DRI 710 Redevelopment of Educomp Building – 4 State Road

Re: DRI 710 Redevelopment of Educomp Building - MVC questions during public hearing

Applicant Answers to Questions raised at the hearing on 4/14/22 – (Updated 06-10-2022)

Easement on Record below;

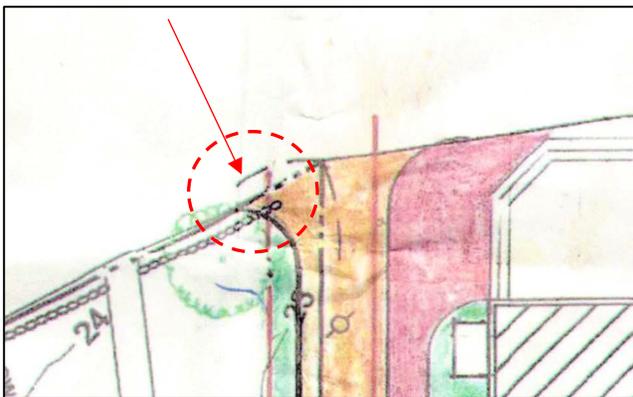
2. Clarify whether the entry driveway will cross the corner of 10 State Road. If not, how will the required turning radius for delivery vehicles be accommodated?

The curve as noted in yellow within the red dashed circle below does cross the corner of 10 State Road to match the current Easement on record. See the Easement on records Exhibit noting curve crossing corner below. 4 State Roads proposed ingress driveway does have additional space to the east of the existing easement on record which we leveraged to accommodate the turning radius for a delivery truck as noted by the red arrow below. By shifting the ingress driveway over in this space, our abutters can maintain additional landscaped space as noted by the blue arrow and benefit from the turning radius for delivery trucks accessing their back parking area.

See plan below that highlights ADA compliant rest areas every 30ft

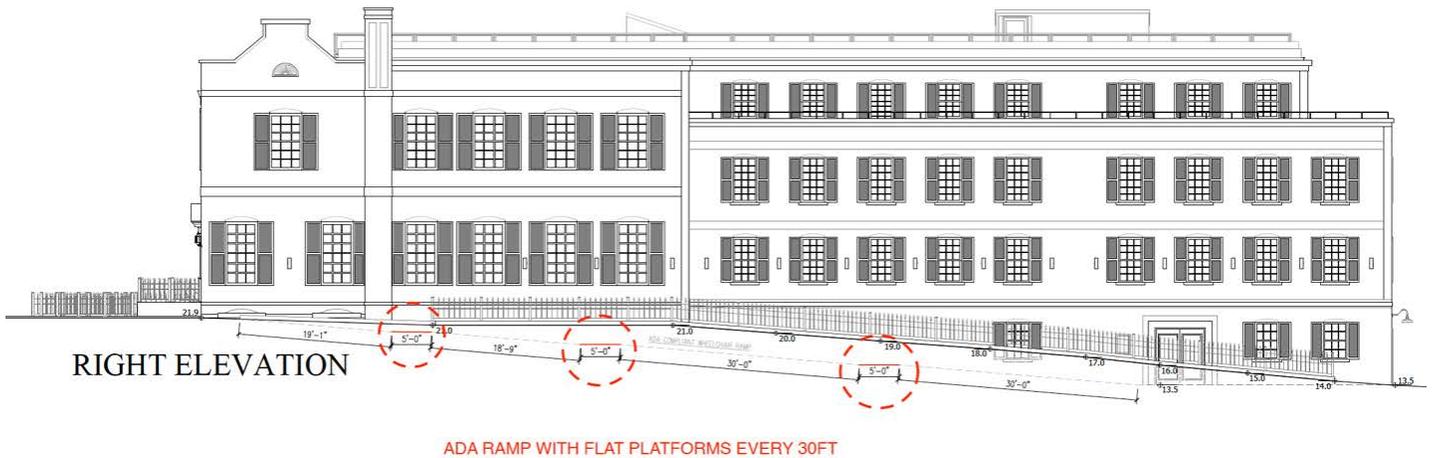
3. Confirm whether the wheelchair ramp will include rests every 30 feet as required for ADA compliance, and show on the elevations.

The wheelchair ramp will include rest areas every 30 feet as required for ADA compliance.

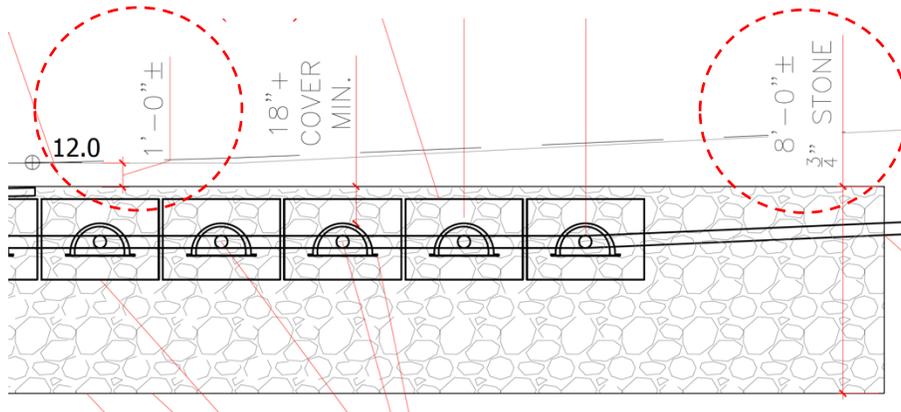
4. Confirm the lowest depth of the proposed stormwater chambers.

Kindly note Stormwater Plan and Capacity Utilization calculation submissions – As depicted in those plans the $\frac{3}{4}$ " Stone chambers lowest depth is 9ft (1ft + 8ft of crushed stone) below elevation of 12.

We offer to engage The Public Archeological Laboratory, Inc. (PAL) to review final storm water plans and follow their advice and recommendations which they deem appropriate with regard to lowest the depth of stormwater chamber.

The chamber volume was over designed with 50% over capacity. Furthermore there is additional area in the rear parking area to expand the stormwater chamber footprint. Thus if PAL recommends a stormwater system that does not go as deep upon completing its investigation – alternative solutions would be at hand to meet the stormwater drainage requirement with a shallower system design. Any change would be submitted to Fraser Engineering for review and approval.

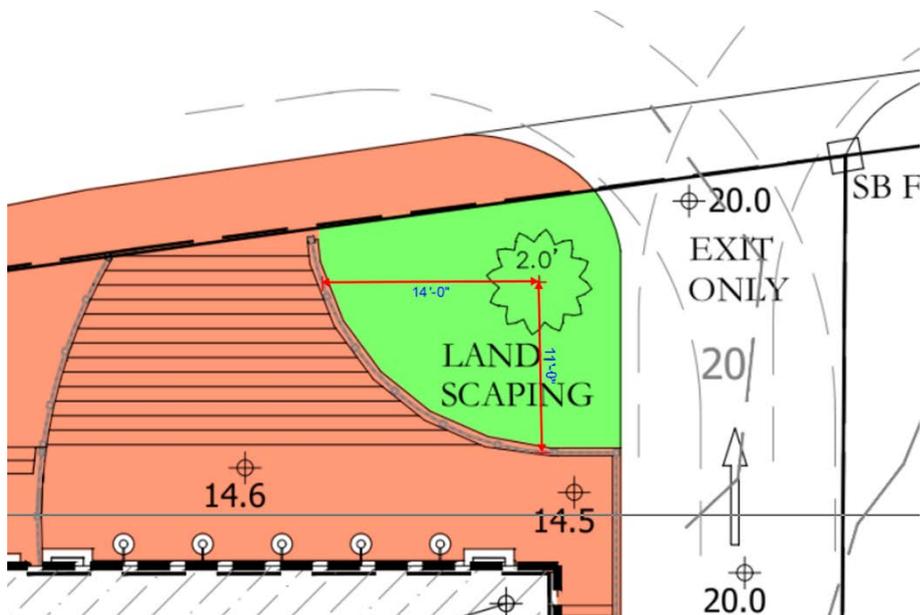
5. Describe how the cherry tree in front will be preserved given the proposed excavation for the front entry and the exit drive, and likely impacts on the root system?

It is our intent to save the cherry tree at the front of the building, hence the design of the curved staircase entrance to the recessed patio.

We offer to engage an island based arborist and follow their recommendations so as to seek guidance and follow their recommendations in our efforts to save the tree throughout the construction period. If despite our best efforts we are unsuccessful in saving the tree – we offer to commit to replacing the tree with a new tree in kind.

We reached out to two local arborists, Bob Haggerty at Haggerty Tree Inc. and Ian Jochems at Jochems Tree Care and Consulting LLC both who have both provided proposals to us for this purpose. Both felt that with the appropriate care and the circumference we have allocated there is a good chance to save the tree. Note proposals attached.

We have over 10ft+ circumference around the trunk before the sunken patio - Closer to 14' going west & 11ft south.

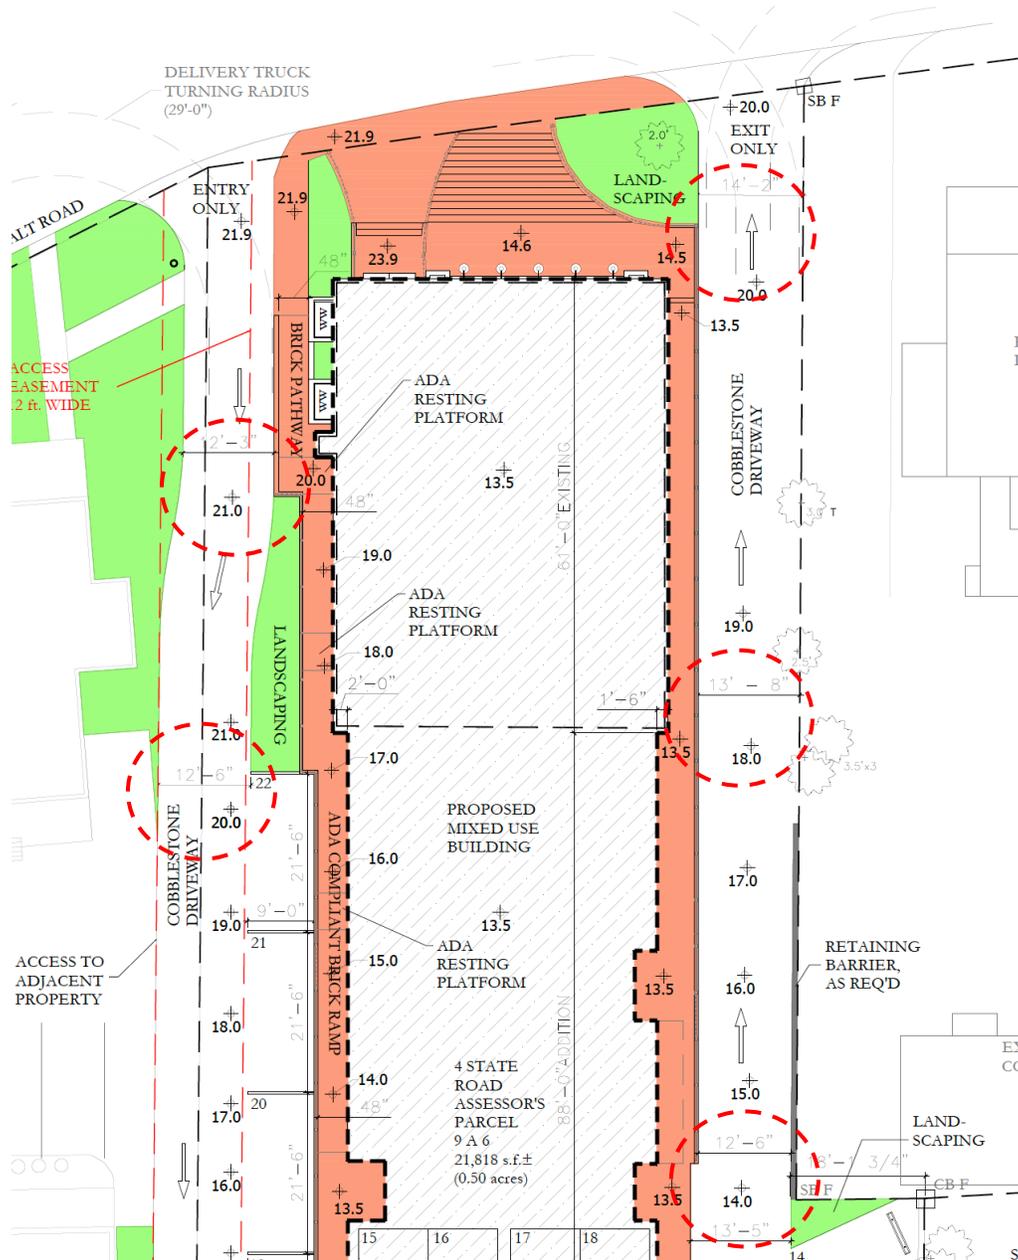
4. *How many trees on the Educomp site will need to be removed? What damage would the revised vehicle access do to vegetation on the adjacent sites?*

We anticipate removing one tree on 4 States Roads lot. A few trees on the easement have been removed by 10 State Rd to make way for the access driveway as approved by the MVC for the access driveway to be located nearer to / on the easement on record.

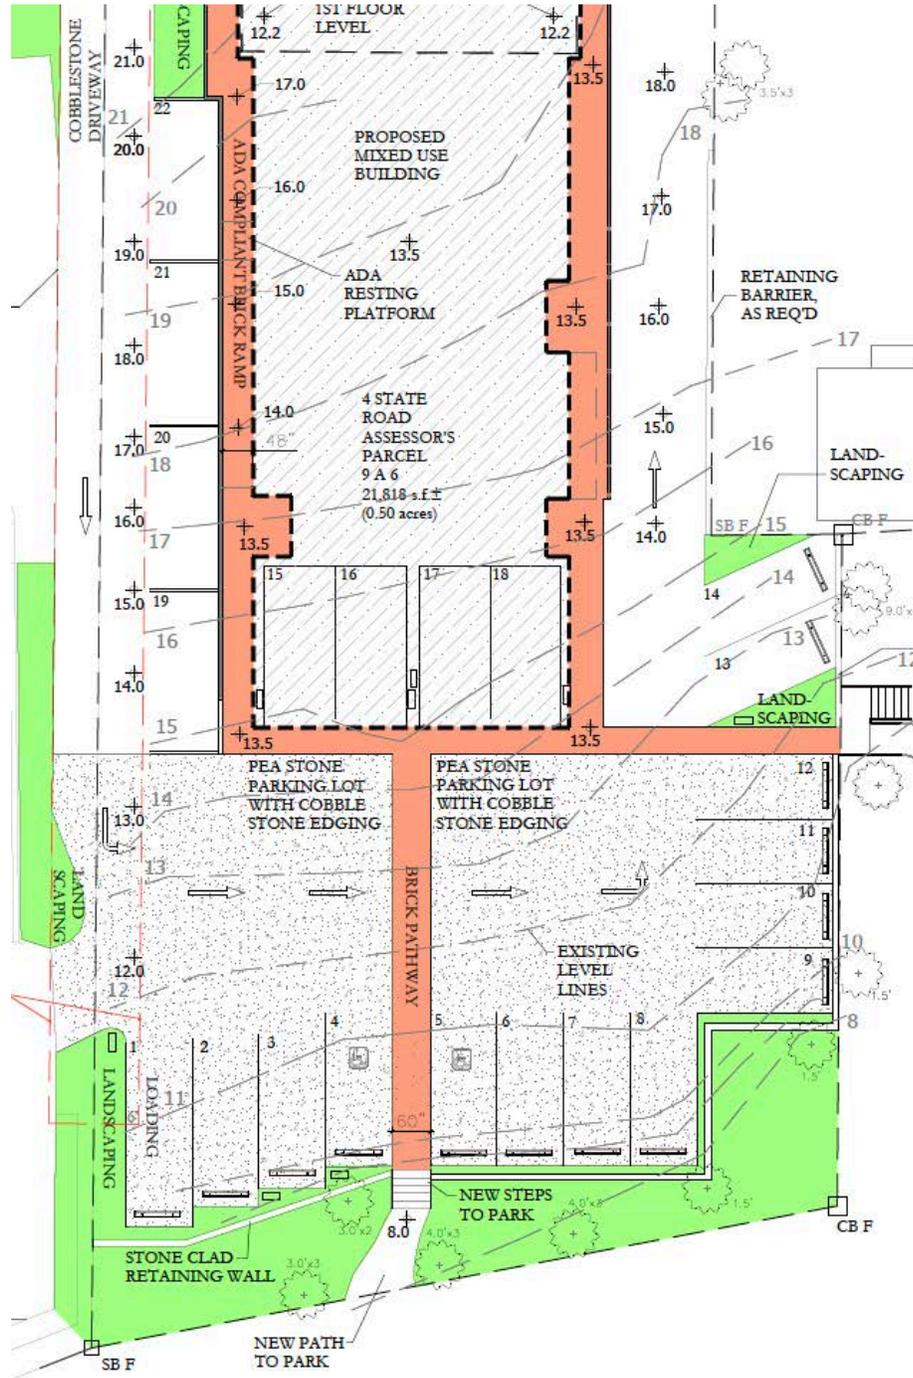
8. *What are the town rights of way on the front of the property? Does there need to be space preserved for sidewalk or bikeway?*

I believe State Road is under the State's jurisdiction. I would defer to the town on the sidewalk and other right of way. We intend to maintain the sidewalks as shown on the plans which is similar to existing conditions.
